CITY OF ST. PETERSBURG, FLORIDA
PLANNING AND DEVELOPMENT SERVICES DEPARTMENT
URBAN PLANNING AND HISTORIC PRESERVATION DIVISION

STAFF REPORT

Community Planning and Preservation Commission Certificate of Appropriateness Request

Case No.:	21-90200067
Address:	3049 7 th Ave. N.
Legal Description:	KENWOOD SUB BLK 4, LOTS 8 AND 9
Parcel ID No.:	14-31-16-46332-004-0080
Date of Construction:	1935
Local Landmark:	Kenwood Section – Northwest Kenwood Local Historic District (18-90300008)
Owners:	Lisa Schweitzer and Myron Cohn
Request:	Review of a Certificate of Appropriateness for the construction of a covered rear porch and front yard fence at 3049 7th Ave. N., a contributing resource to a local historic district

Figure 3: Staff photograph of front yard fence

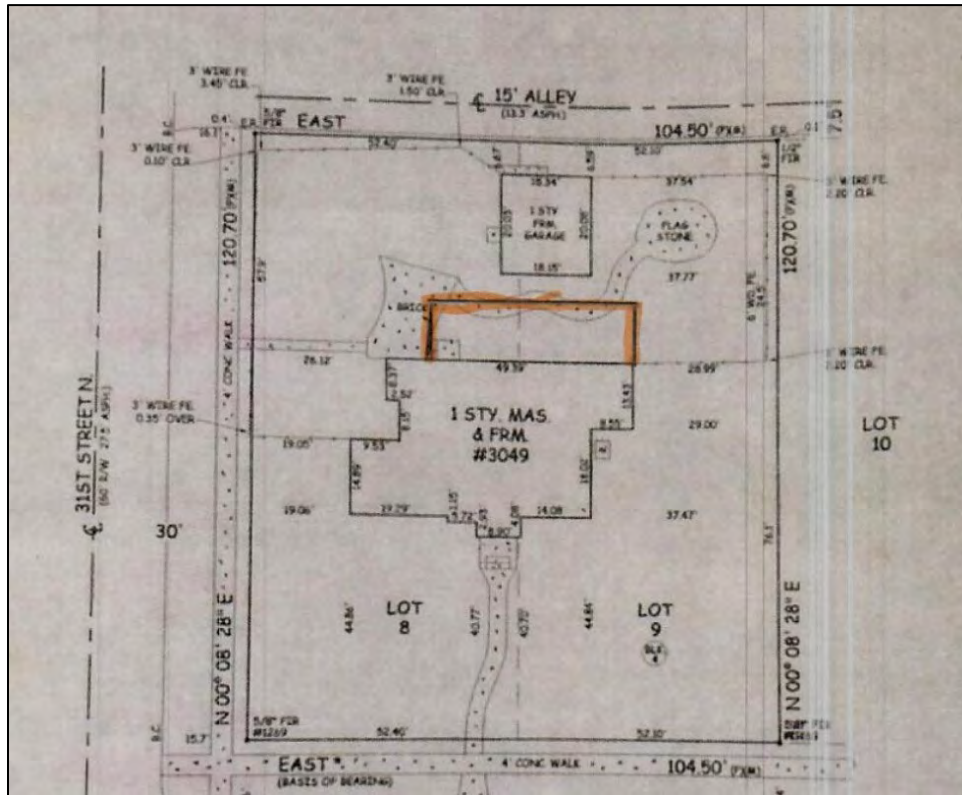
Inconsistent As discussed in the cases of proposals that have come before this Commission in the recent past, fences were less common during Kenwood's Period of Significance than they are now, and open front yards appear to have been particularly favored over individual fenced front gardens.

However, low wood fences with high transparency have become more common throughout the district to accommodate increased recreational use of outdoor spaces. Staff typically recommends that front fences, where necessary, be limited to approximately three feet and feature at least 50 percent transparency to mitigate their visual impact and allow the retention of partial sight lines of the district's front gardens and primary residences. This is important to retain the overall pedestrian orientation that characterizes the historic district. Examples of this style of fence in the subject district are shown below.

Partially Consistent The proposed fence creates a visual enclosure of the subject property's front yard, thus changing the historic rhythm of the streetscape. However, its wood material is appropriate for the subject district.

The front fence, while being constructed of wood, creates a visual barrier due to its relatively low transparency and tall height as compared to other front fences approved by this Commission. Front yard fences are generally out of context within the Kenwood historic districts but have been approved in certain cases to accommodate owners' changing expectations of privacy and use of garden space. However, staff recommends that the height and design of front fences take the district's historic context into consideration by limiting their visual impact as much as possible when they are necessary.

Staff recommends **denial** of the after-the-fact application for the front yard fence.

Figure 10: Section of survey with proposed location of porch highlighted, from application materials

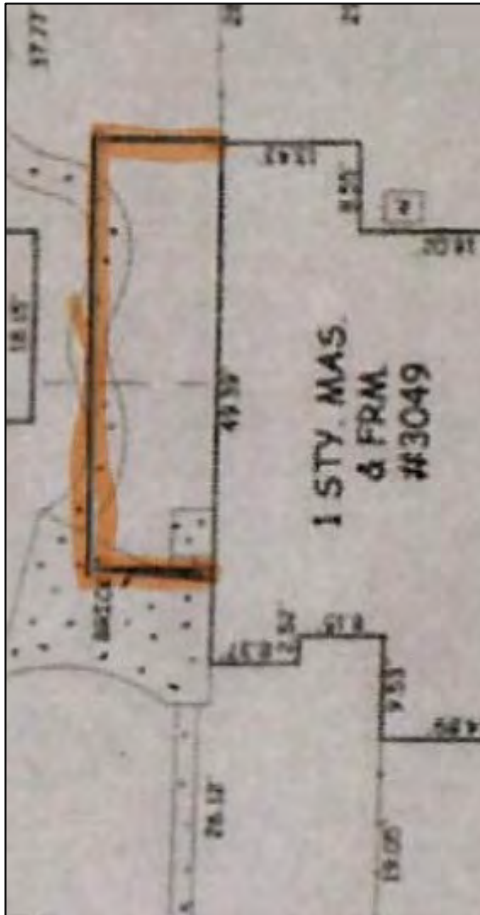
Consistent The patio roof will be attached to the residence beneath the first floor fascia line and feature a shed roof, thus restricting the height to below that of the primary resource.

Consistent The porch addition will be approximately 40 feet at its widest point, and located behind the rear elevation which is 50 feet wide.

Consistent The proposed porch addition will be located behind the primary residence at the subject property. It will extend into the rear yard and may be visible from the street side yard but will retain the separation of structures.

- PROPOSED FOR -
3049 7th AVE S.

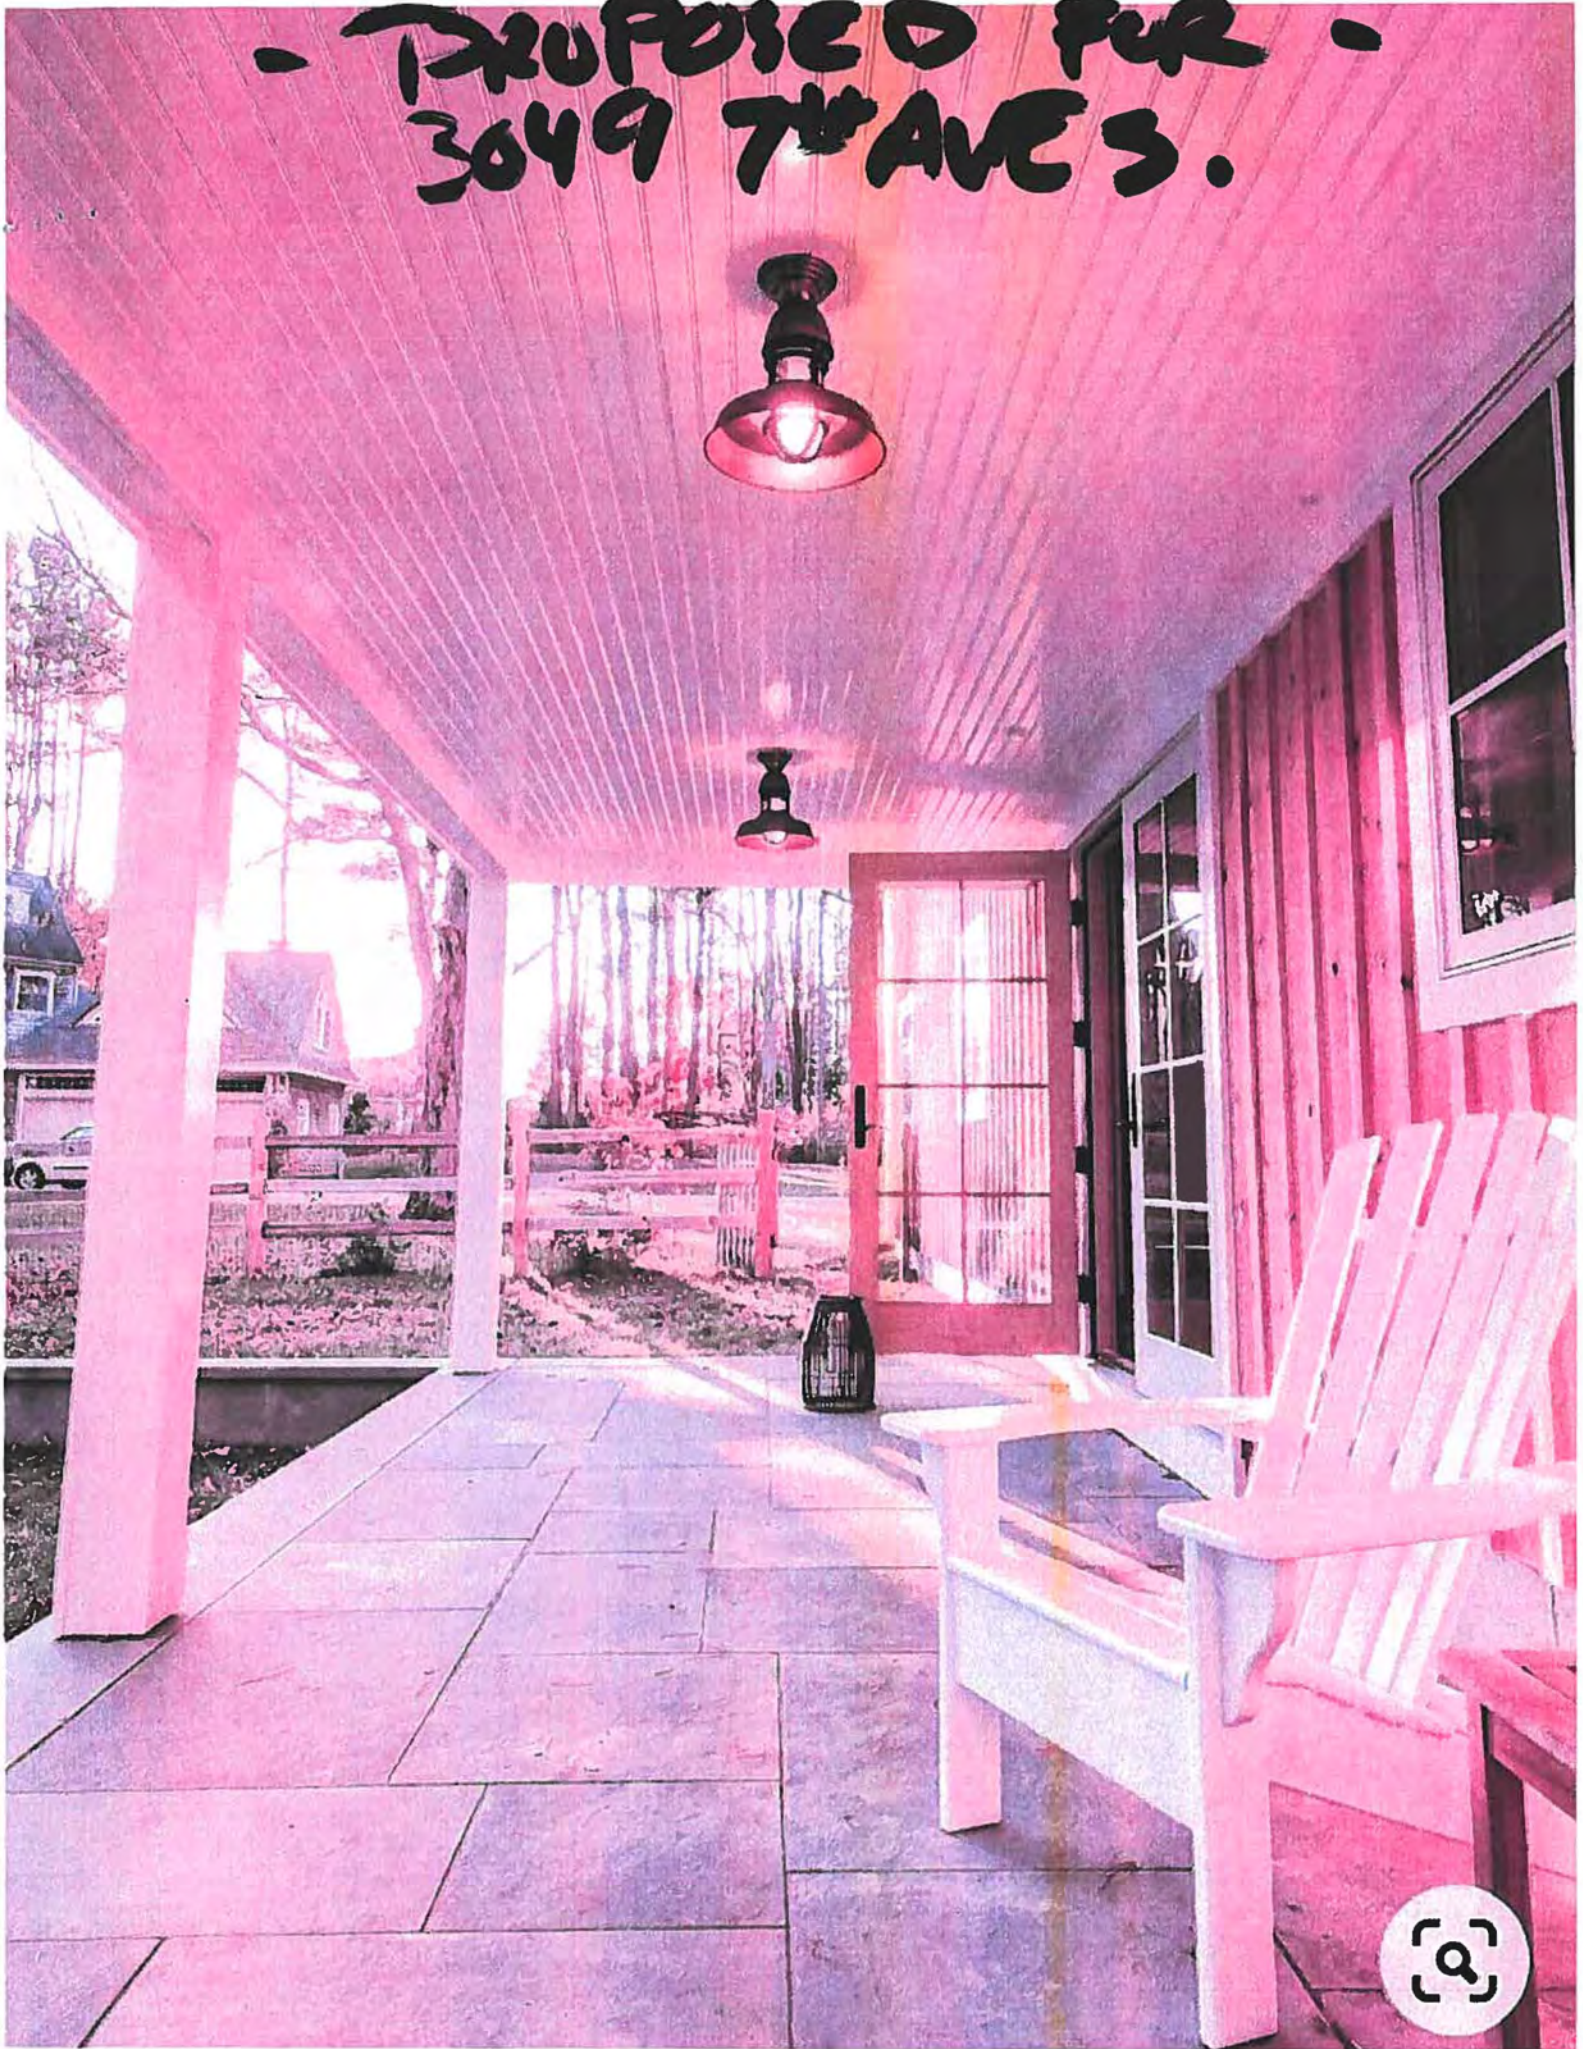
Partially Consistent The proposed rear structure porch is to be constructed of a foam composite material clad in vinyl and placed atop a poured concrete slab. Though located at the rear of the primary residence and not impacting the appearance of the façade, the flat-roof design and contemporary materials are not typical to the subject district.

Inconsistent The application proposes a foam and aluminum structure, which is not a traditional construction method.

Generally consistent The proposed roof will be nearly flat with a slight slope. Shed, gabled, or hipped roofs were more commonly constructed during the historic era, but flatter roofs were sometimes used, particularly for mid-century additions.

Based on a determination of general consistency with Chapter 16, City Code of Ordinances, staff recommends that the Community Planning and Preservation Commission **approval of** the Certificate of Appropriateness request for the installation of a rear porch at 3049 7th Ave. N., a contributing property to the Kenwood Section – Northwest Kenwood Local Historic District, with the following conditions:
